Central Valley Regional Water Quality Control Board
27-28 April 2023 Board Meeting

Response to Comments
for the
City of Mt. Shasta and U.S. Department of Agriculture Forest Service
City of Mt. Shasta Wastewater Treatment Plant
Tentative Waste Discharge Requirements

See the WET Monitoring Flow Chart (Figure F-1), below, for further clarification of the decision points for determining the need for TES/TRE initiation.

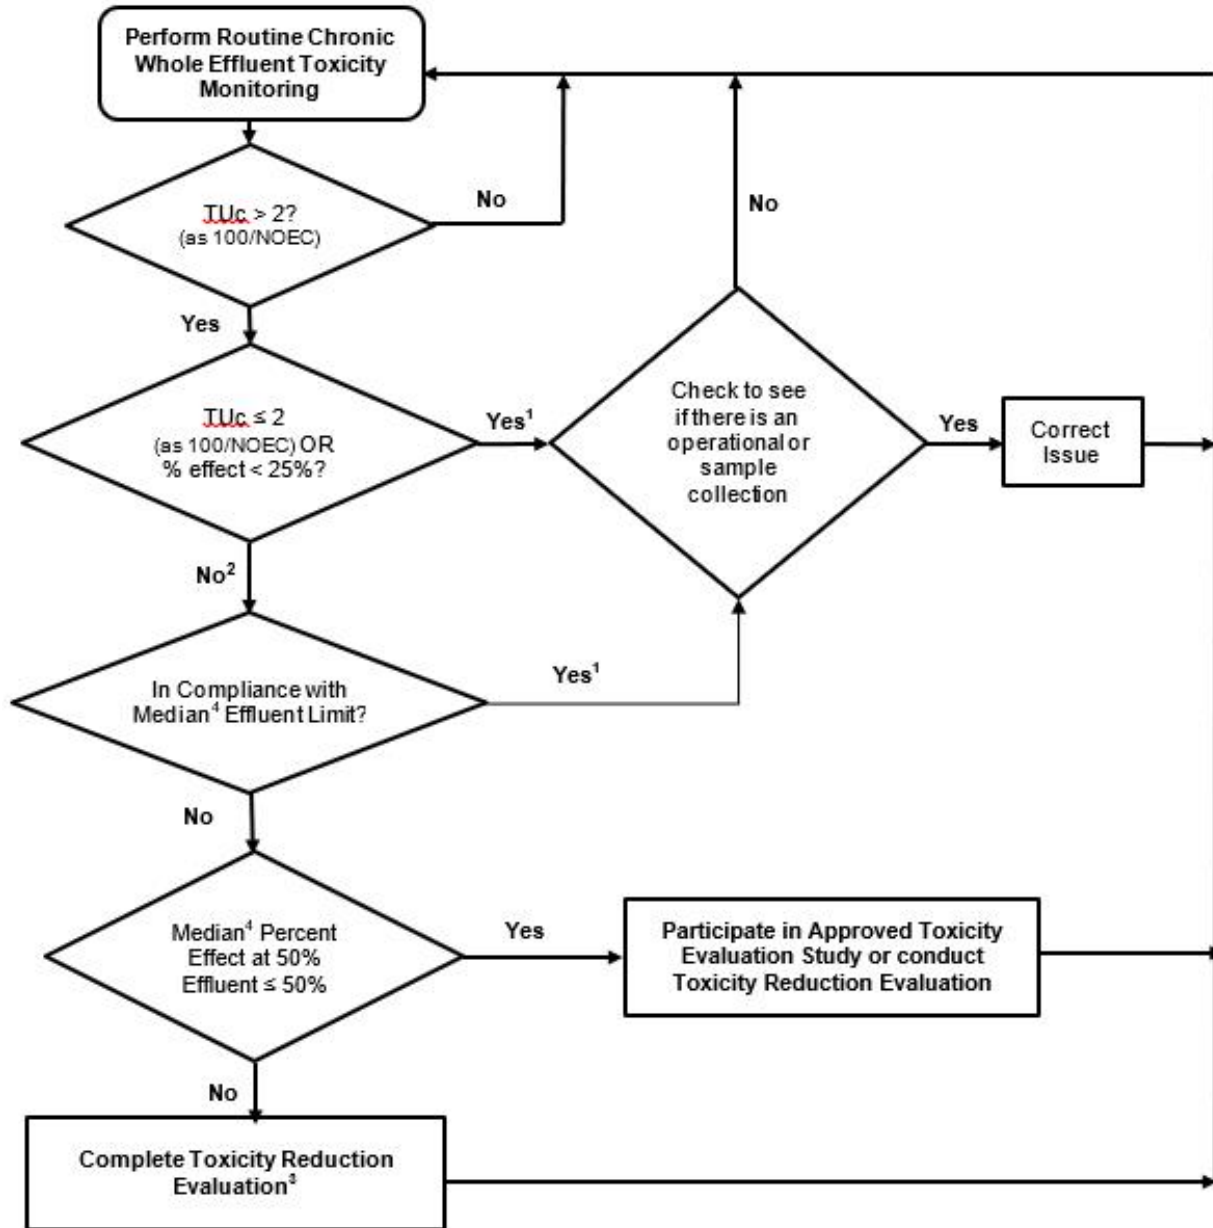
Fact Sheet section VI.B.2 has been revised as follows to include Toxicity Reduction Evaluation Requirements:

The Monitoring and Reporting Program of this Order requires chronic WET monitoring to demonstrate compliance with the numeric chronic toxicity effluent limitation. If the discharge exceeds the chronic toxicity effluent limitation, this provision requires the Discharger either participate in an approved Toxicity Evaluation Study (TES) or conduct a site-specific Toxicity Reduction Evaluation (TRE).

A TES may be conducted in lieu of a TRE if the percent effect at 50 percent effluent is less than or equal to 50 percent. Determining the cause of toxicity can be challenging when the toxicity signal is low. Several Central Valley facilities with similar treatment systems have been experiencing intermittent low-level toxicity. The dischargers have not been successful identifying the cause of the toxicity because of the low toxicity signal and the intermittent nature of the toxicity. Due to these challenges, the Central Valley Clean Water Association (CVCWA), in collaboration with staff from the Central Valley Water Board, has initiated a Special Study to Investigate Low Level Toxicity Indications (Group Toxicity Study). This Order allows the Discharger to participate in an approved TES, which may be conducted individually or as part of a coordinated group effort with other similar dischargers that are exhibiting toxicity. Although the current CVCWA Group Toxicity Study is related to low-level

1. The Discharger may participate in an approved TES if the discharge has exceeded the chronic toxicity effluent limitation twice or more in the past 12-month period and the cause is not identified and/or addressed.
2. The Discharger may elect to take additional samples to determine the 3-sample median. The samples shall be collected at least one week apart and the final sample shall be within 6 weeks of the initial sample exhibiting toxicity.
3. The Discharger may participate in an approved TES instead of a TRE if the Discharger has conducted a TRE within the past 12 months and has been unsuccessful in identifying the toxicant.
4. See Compliance Determination section VII.I for procedures for calculating 6-week median.
